IDAP REPORT

Property:	23 Elliott Street Belfield LOT A in DP 323568 DA 2021/297
Proposal:	Alterations and additions to existing dwelling house including demolition and reconstruction of carport, rear extension, new first floor addition and new front fence.
Applicant:	A Leone
Owner:	Mark and Michelle Kazzi
Date of lodgement:	16 November 2021
Notification period:	19 November to 3 December 2021
Submissions received:	Nil
Assessment officer:	L Fanayan
Estimated cost of works:	\$488,400.00
Zoning:	R2-Low Density Residential - SLEP 2012
Heritage:	No
Flood affected:	Yes
Is a Clause 4.6 Variation Proposed:	No
RECOMMENDATION OF OFFICER:	Approval

Figure 10: Existing carport location showing measurements of setbacks

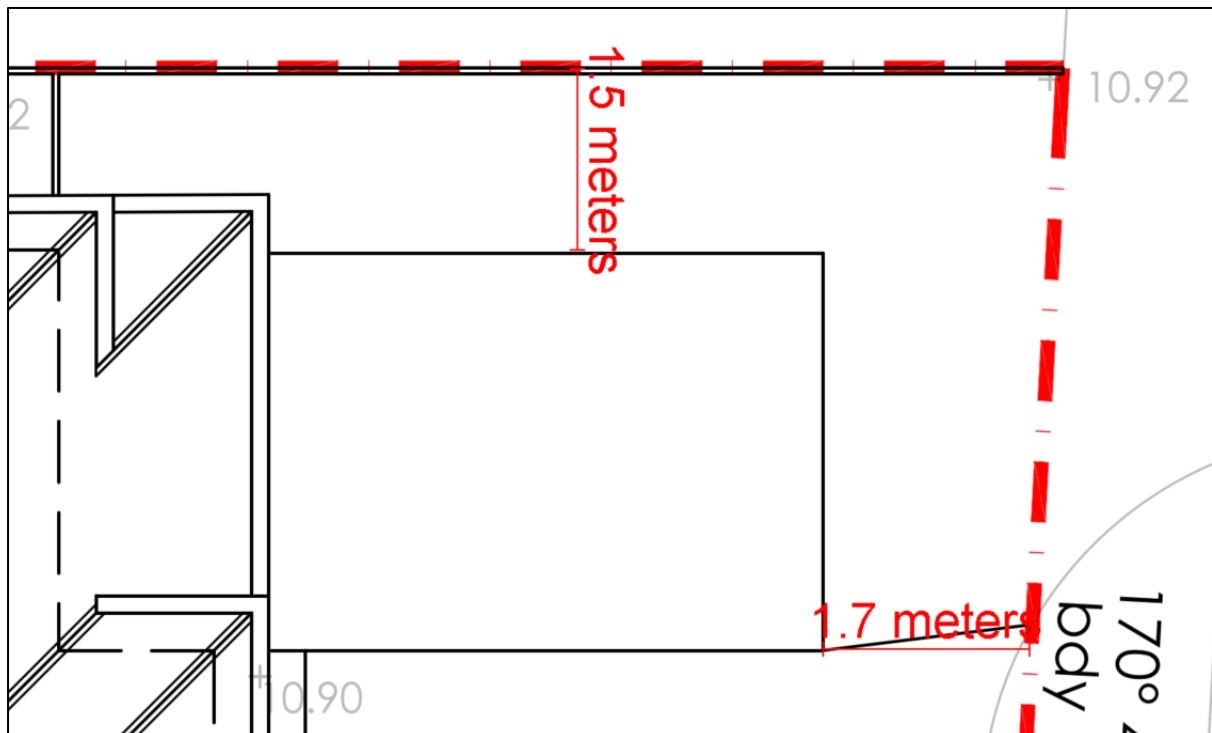
The site has an existing car port approved by a Land and Environmental Court decision (Building Permit No. 133.86, 24 December 1986). The existing carport roof is setback 1.7m from the boundary at its closet point (see Figure 10). The proposed carport has a measurement of 1.4m in the same location (see Figure 11). The proposed carport will be accepted in the front yard however it is to match the existing setback to the front boundary, therefore it will be conditioned through design changes that the carport roof is to remain 1.7m from the front boundary.

The front setback to the dwelling remains the same at 6.45m, there are no alternations proposed to the façade of the dwelling.

Alfresco glazing	Amend elevation plans to show glazing on the northern face of the alfresco as obscured glazing.
Carport Setback	Amended plans and details are required to show the proposed carport roof not extending towards the front boundary any further than the existing carport roof.
Landscape Plan	Amend the landscape plan to show two (2) canopy trees, one (1) in the front yard and one (1) in the rear yard, capable of reach 10m.

Figure 12: Plan view of the void space

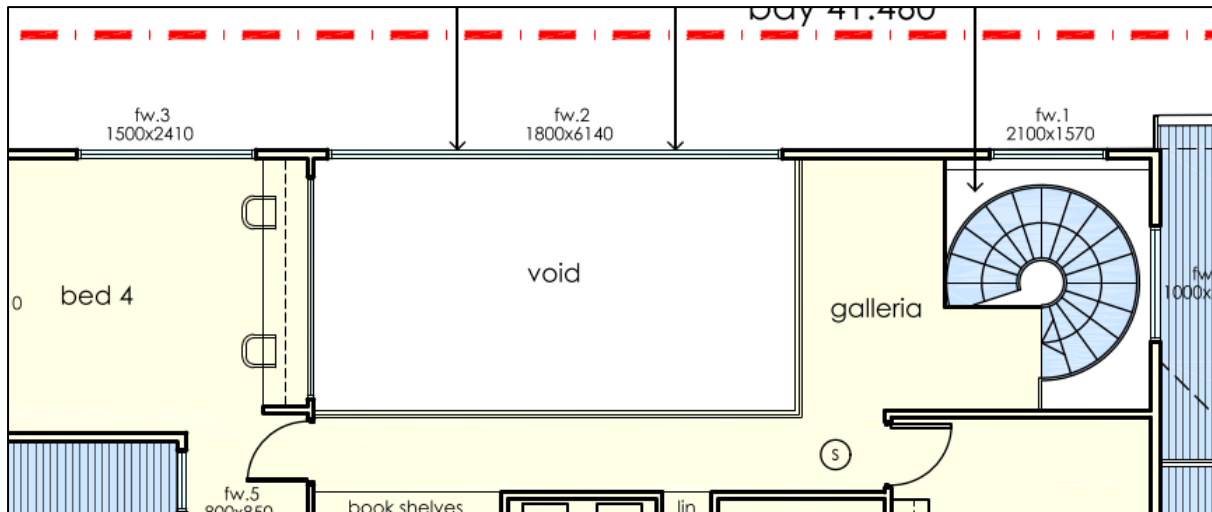
The void space above the dining/living is accepted, it receives northern solar access and provides great solar amenity. The void space above the dining/living area is large, however, if the void was to be included as GFA it would still be compliant with the FSR development standard for the site. Void space is 21.7m² and if included provide a total of 283.2m² of GFA and a total of 0.63:1 FSR.

The void adds bulk to the northern elevation which adjoins a public open space/park. This is of little concern as it is not imposing on residential living and the park includes a number of trees that buffer the view toward 23 Elliot and the first floor addition. On balance, it is deemed an appropriate design due to the nature of the property's adjacent land use and overall size of the dwelling.

To ensure that the void space above the living/dining room remains a void an ongoing condition will be included in the consent.
